## 20/5102D Objection – Henbury Parish Council

Henbury Parish Council submitted an objection to the reserved matters application (19/3097M) and wish to submit an objection to the discharge of the drainage and travel plan conditions under 20/5102D.

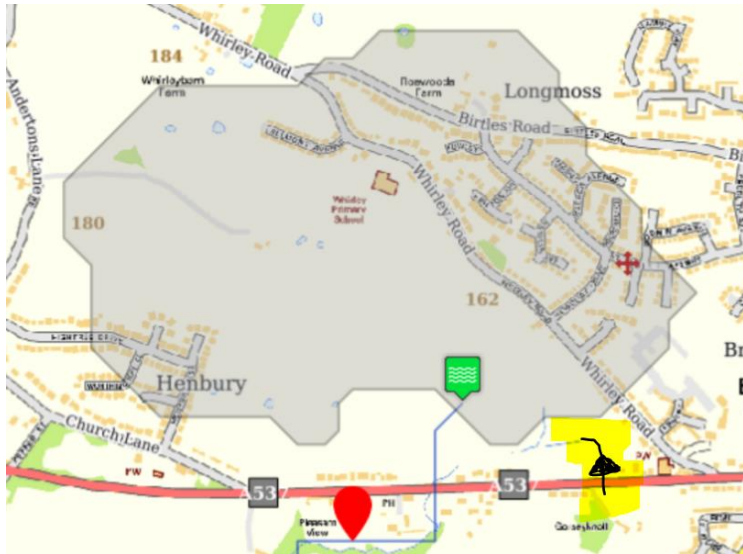
- The catchment area shown in the 'Watercourse catchment' document is incomplete. There is a stream that feeds the site from the south of the A537, highlighted on the below picture with flow direction indicated. This joins the existing watercourse and proceeds to Cock Wood via the existing culvert. Therefore, the catchment producing this should be included, which is the higher land to the south of the site.

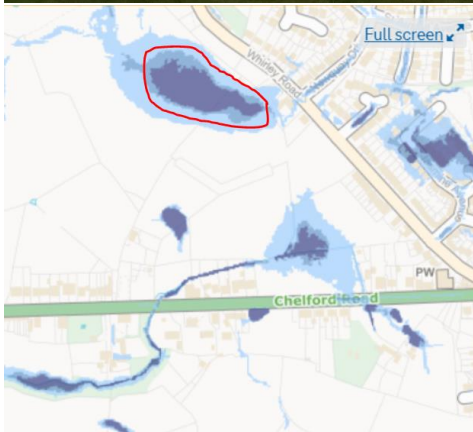
None of the documentation provided for this site mentions the impact on the surface water on the neighbouring land. The below photograph shows the north-west site boundary marked red, when

viewed to the east from the neighbouring field. The proposals show that the surface water will not be present at the location of the tip of the red arrow, but that there will be a pond to the right of this. If the surface water is removed will this also mean that the whole of this flooded area will be drained? This is a valuable, and well used, habitat for waterfowl in the winter months and adds greatly to the local area. The impact should be made clear. The area in question is outlined in red on the government surface water flood risk map, below the photograph.
